STRUCTURAL EVALUATION OF
JOHN F. KENNEDY HIGH SCHOOL
WEST CONTRA COSTA UNIFIED SCHOOL DISTRICT
(WCCUSD)

WLC Architects
Kaiser Building
1300 Potrero Avenue
Richmond, CA 94804

DASSE Design, Inc.
33 New Montgomery Street #850
San Francisco, CA 94105
(415) 243-8400

October 17, 2002

Drawing 1: Building I Foundation Plan

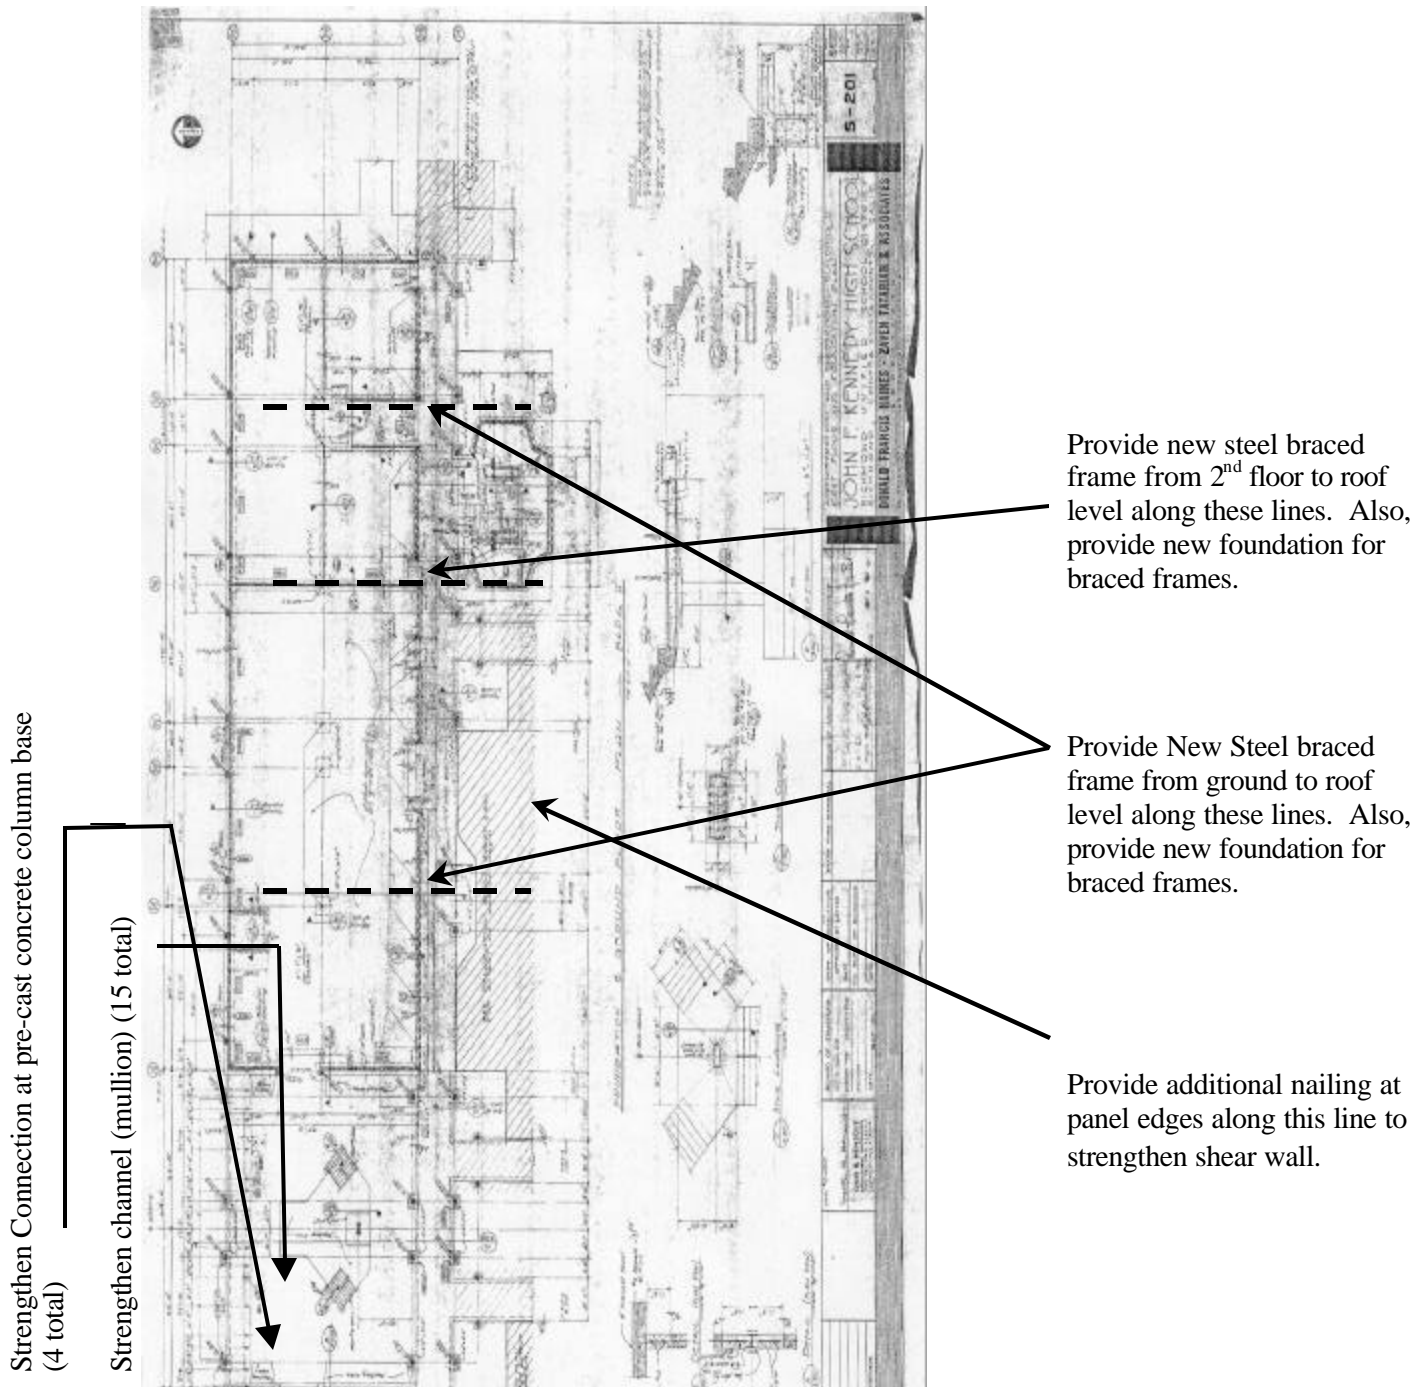
In Building I, the interior transverse (north-south) shear walls in the second story do not line-up with the walls in the first story creating an out-of-plane offset that results in a discontinuity in seismic load path. This irregularity is called a plan irregularity and could result in overstressing of the second floor diaphragm and the 3x16 joists that support the upper plywood shear walls in the upper story. Additionally, hold downs required at the ends of the shear walls in the second story are not present. This irregularity represents a life safety hazard. New steel braced frames and foundations as shown in appendix "B" drawings should be provided from the ground to the roof level.

2.	Buildings I & II - Interior transverse plywood shear walls have plan irregularity. This results in overstressing of the 2 nd floor diaphragms and overstressing of the 4-3x16 joists that support the 2 nd floor shear walls. Additionally, holddown ties at the 2 nd floor shear walls are not present.

2.	Provide new steel braced frames from ground to roof level	1.0	1
3.	Provide positive connection between the glu-lam beams and the pre-cast panel to transfer collector force. Also provide strap across glu-lam beams to provide continuity	1.1	2A

Provide new steel braced frame from ground to roof level along these grid lines. Provide new foundations for braced frames.

Drawing 2A: Building II Foundation Plan

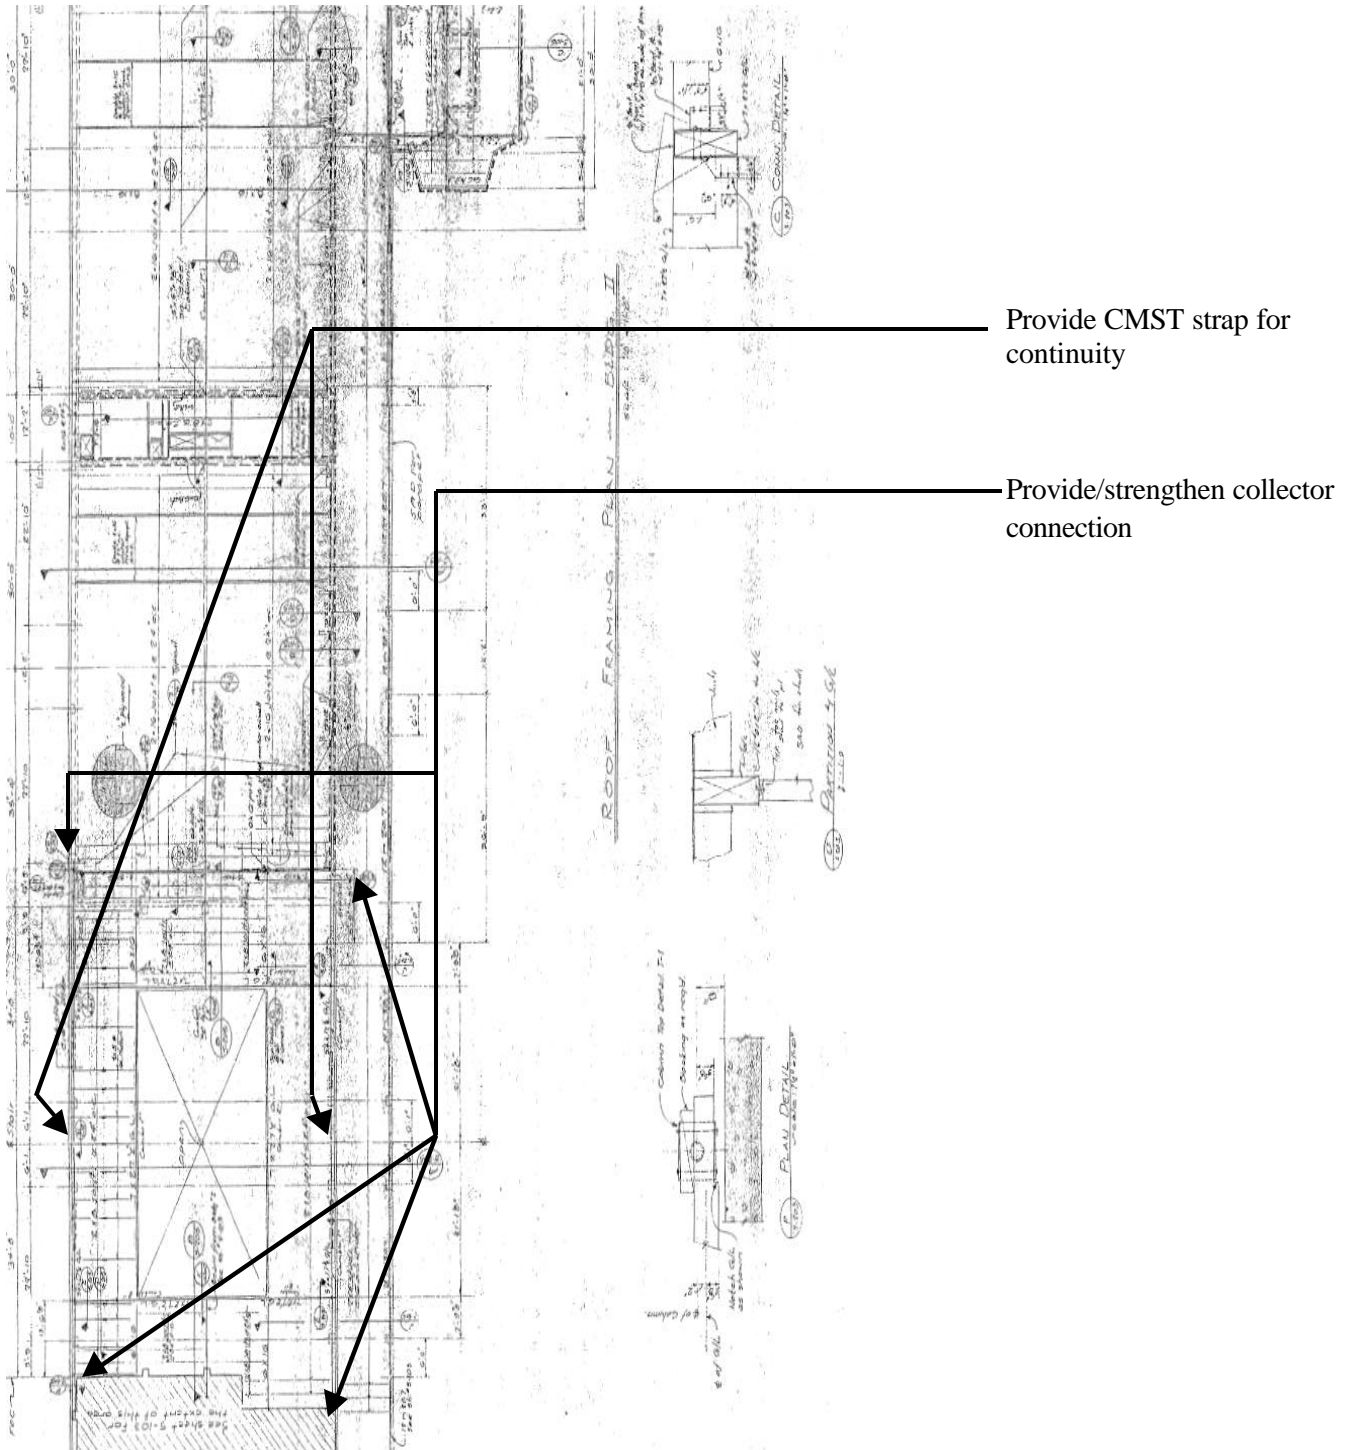
3.	Building I&II – Entrance lobby roof - On lines A and C glu-lam beams lack continuity and needs to be positively connected to develop connector force to transfer roof diaphragm forces.

Drawing 3: Building IV Foundation Plan

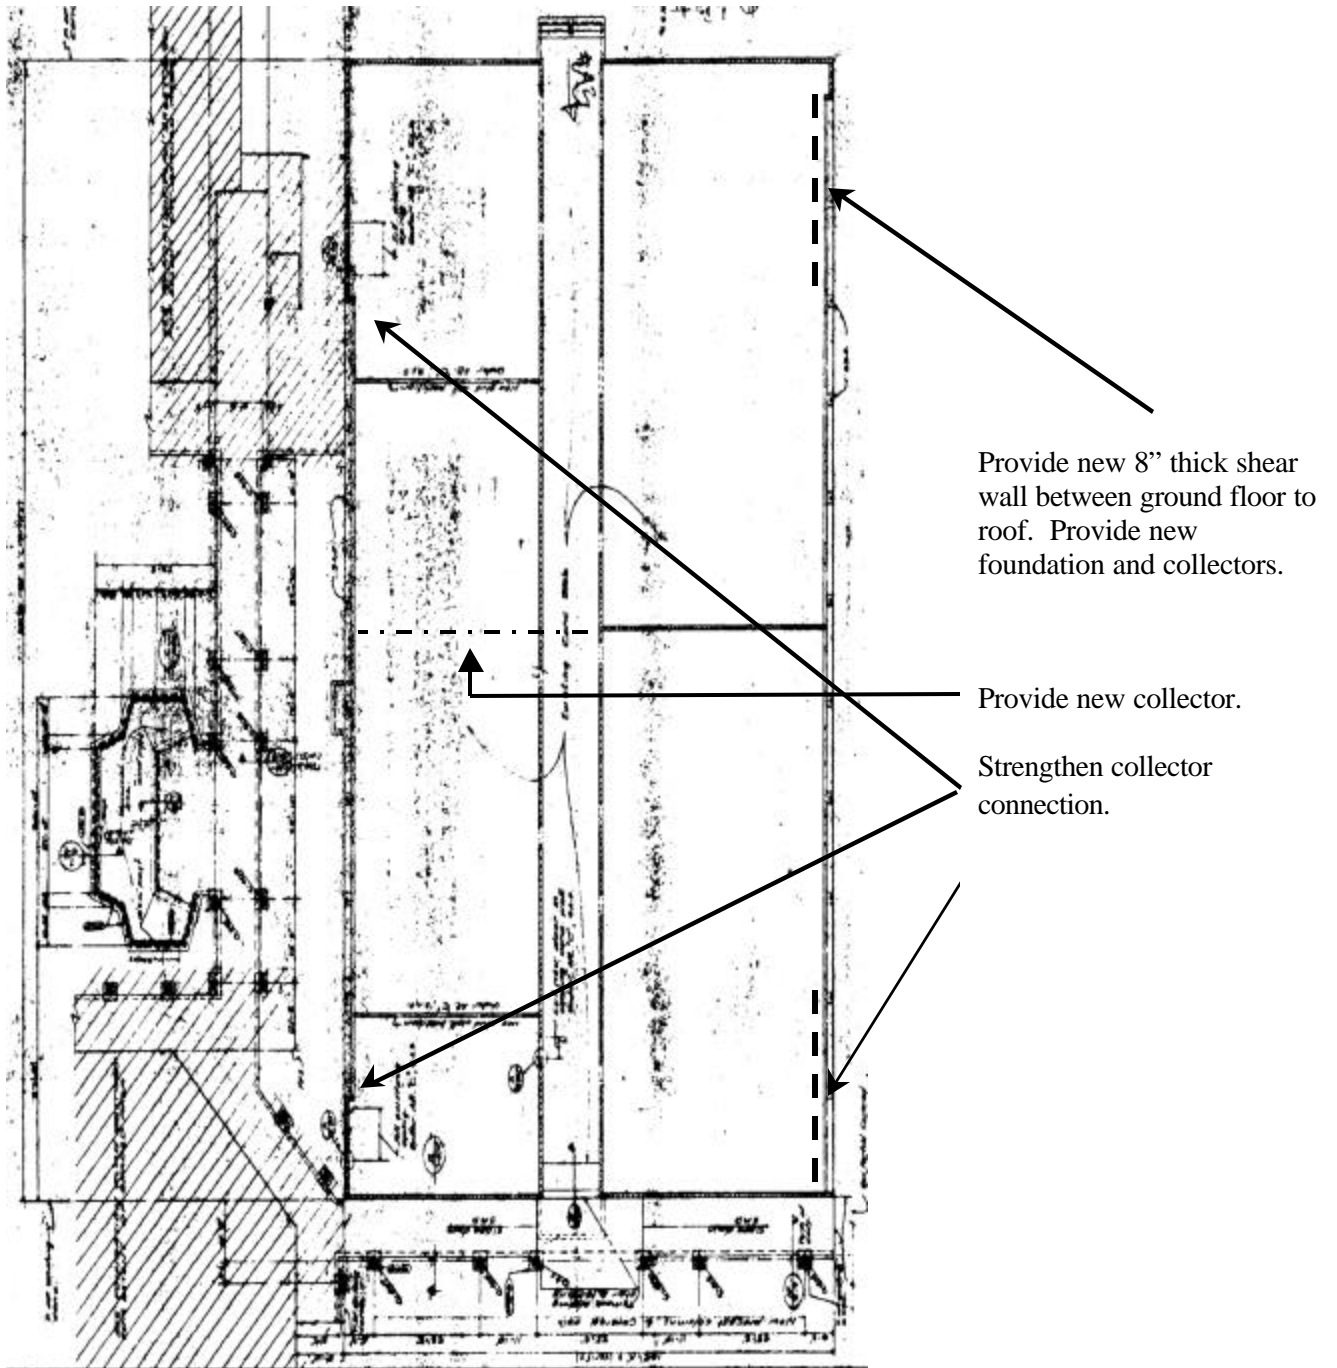
5.	Building II - Plywood shear walls at 1 st floor at the South face of the building lack adequate shear strength to resist prescribed seismic forces.
6.	Building IV – Longitudinal wall on the south has excessive openings and lack adequate length of shear wall to resist seismic forces.

7.	Building IV – Collector connection to pre-cast concrete wall on north longitudinal wall is inadequate.
8.	Building IV – Interior shear wall in transverse direction needs a collector to drag

5.	Provide additional nailing at panel edges and wall perimeter to strengthen existing plywood shear wall	1.5	2
6.	Fill-in existing window for two bays at each end with new 8” thick wall and strengthen foundation as required and provide collector connection	1.1	3

7.	Strengthen collector connection to pre-cast concrete wall on north longitudinal	1.5	3
8.	Provide new collector to transfer seismic forces	1.5	3
9.	Strengthen the plywood shear walls with additional nailing at the panel edges and wall perimeters, staggered with the existing nails	1.1	4

Drawing 4: Building V Foundation Plan

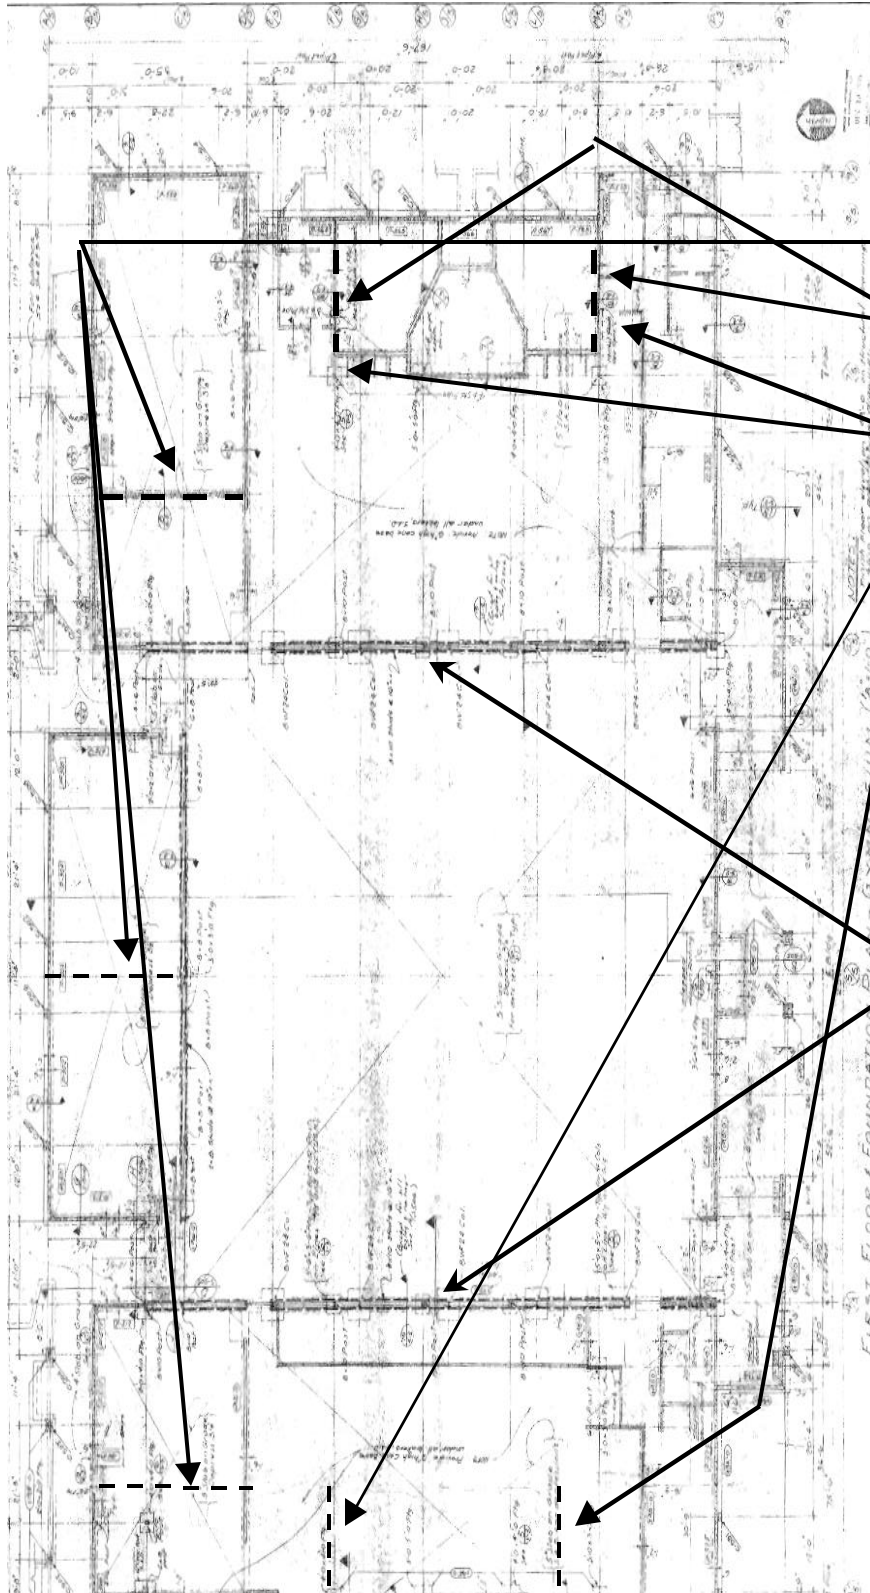
The plywood diaphragm between D/3 and P/5 in the locker room area has inadequate strength to resist prescribed seismic loads in east-west direction due to the long span of the diaphragm. New plywood shear walls, hold downs and collector connections should be provided as shown in drawing appendix "B".

The plywood diaphragm at the dance floor area, weight room and wrestling area between grids B/5 and D/5 has inadequate strength to resist prescribed seismic loads. New plywood sheathing should be added to existing partition walls between 6/5 and 7/5 in the music room, which will create new shear walls and reduce the diaphragm spans. New plywood shear wall should be added on line 5/5 between grids B/5 and D/5 at the weight room and on line 3/5 between grids B/5 and D/5 at the wrestling area.

seismic loads.
9.	Building V - Plywood shear walls along East and West boundary of gymnasium lack adequate strength to resist prescribed seismic forces

Add new plywood sheathing to this face

New plywood shear wall

Provide new collector connection at roof level

Strengthen shear walls by providing additional nailing (stagger with existing)

Drawing 6: Building VI Roof Plan

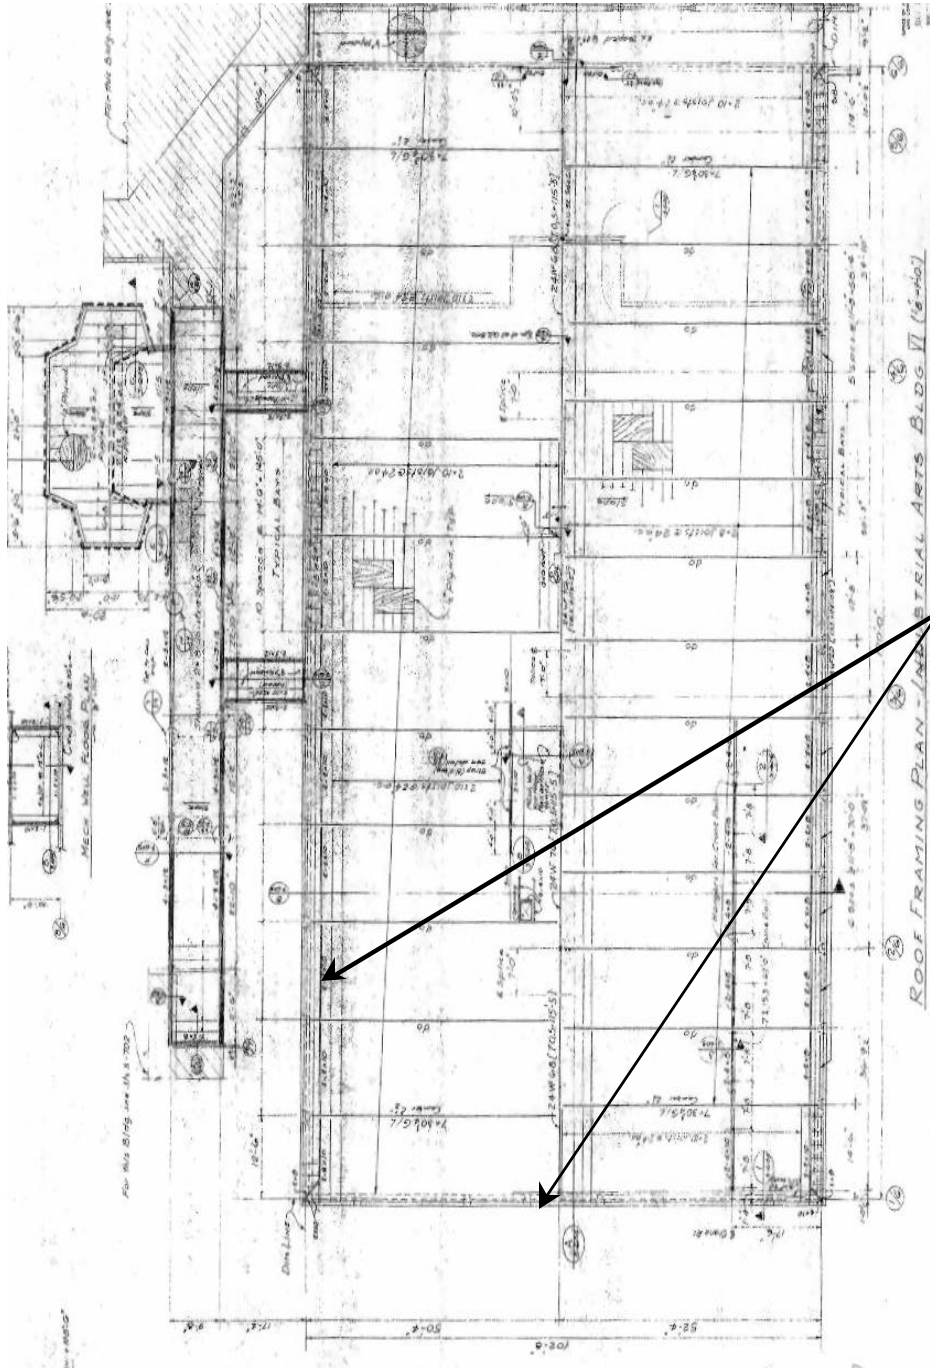
15.	Building V – Top plates at gymnasium high roof are discontinuous and thus not providing continuity of chords required to resist seismic loads.
16.	Building VI - Pre-Cast concrete wall anchorage connections to roof lack adequate strength to resist the prescribed out-of-plane seismic forces

17.	Building VI - In-plane shear-transfer connections between diaphragm and shear walls lack adequate strength to transfer prescribed seismic forces.
18.	Building VI - Roof diaphragm lacks adequate shear strength to resist prescribed seismic forces.

Strengthen connection between perimeter tilt-up and roof for wall out-of-plane loads typical

Provide additional nailing to strengthen existing roof diaphragm on Lines 1/6 and 6/6

Drawing 8: Building VII Foundation Plan

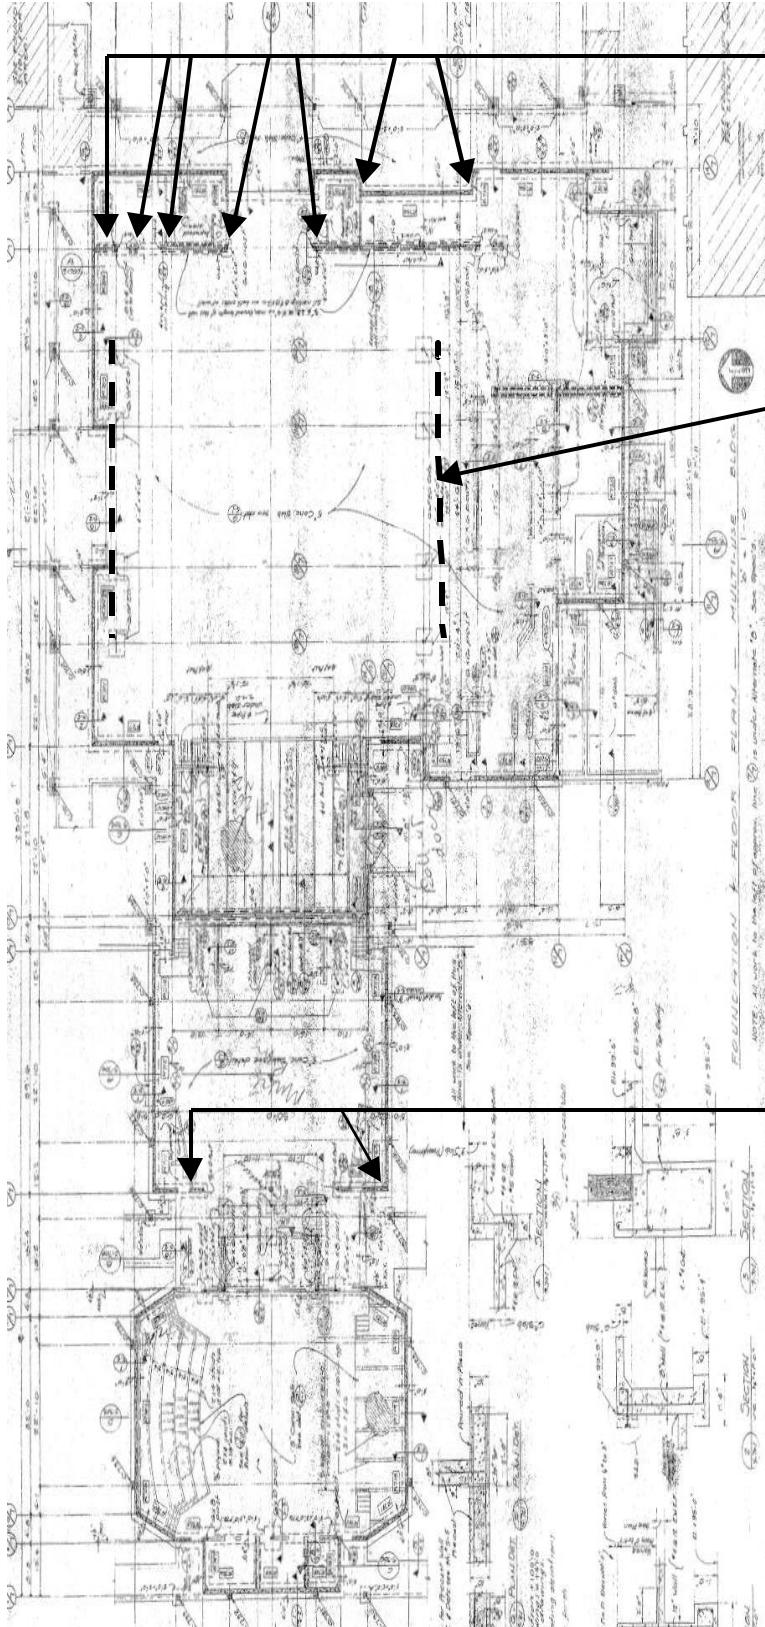
The MPR has discontinuous shear walls in the east-west direction on lines B/7 and M/7 which poses a life safety hazard. A new lateral system such as a steel braced frames with new foundations should be added along the above grid lines to resist prescribed seismic loads and provide a complete lateral load path from the cafeteria roof to the foundation. It should be noted that on line M/7, there is a short piece (7'-7" length and 9'-6" tall) of 10" thick poured in place concrete wall near line 10/7 in north-south direction, which is connected to exterior pre-cast concrete wall. Since the pre-cast walls do not have hold downs to resist seismic overturning forces, the poured in place concrete wall will experience uplift forces. Also, the poured in place

23.	Building VII – Shear walls on lines B/7 and M/7 supporting cafeteria roof are discontinuous and there is no path to transfer roof diaphragm forces to foundation.

Provided hold-down anchors
at ends of tilt-up panels

Provide new braced frame
on lines B/7 & M/7 from
ground to multi[purpose high
roof and collectors as
required.

Provide hold-down anchors
at ends of tilt-up panels.

NOTE: Strengthen
connection between
perimeter tilt-up panel and
roof (for wall out-of-plane
loads) typical.
